Model: PR-C151

No. : ECN20T024KGC-00

Subject: Change of printer controller firmware/ Countermeasure for EOL of ink ribbon

Fig. 1

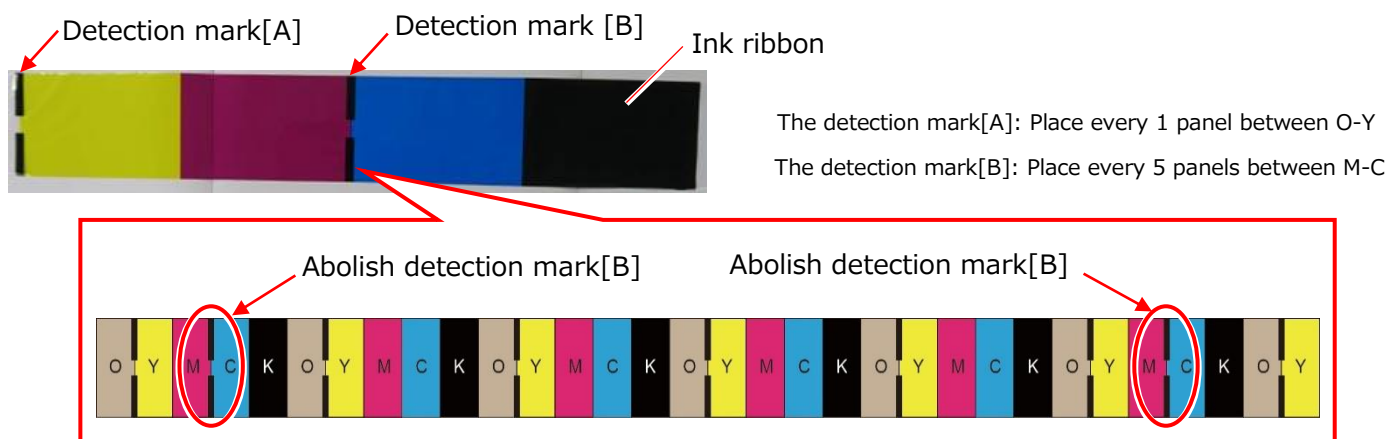
1-2. Change : Abolish the detection mark [B] between M-C.

No.	Item	Detail
1	Countermeasure for EOL of ink ribbon	Due to abolishing the detection mark [B] of the ink ribbon, it is changed to "detection mark [B] detection sequence". This makes it possible to compatible with the old and new ink ribbons.

Fig. 2

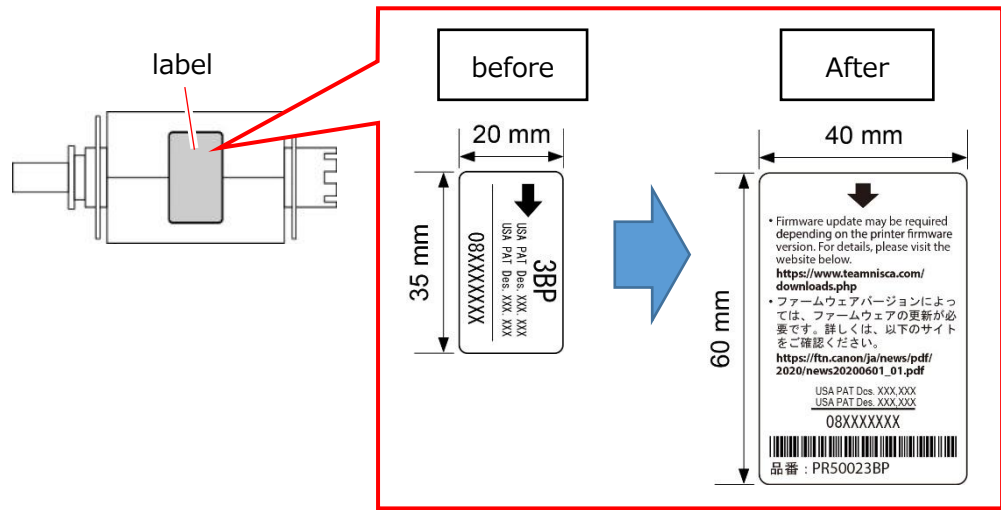
3-1. Change the attached label on ink ribbon and “the information for firmware version up” will be added.
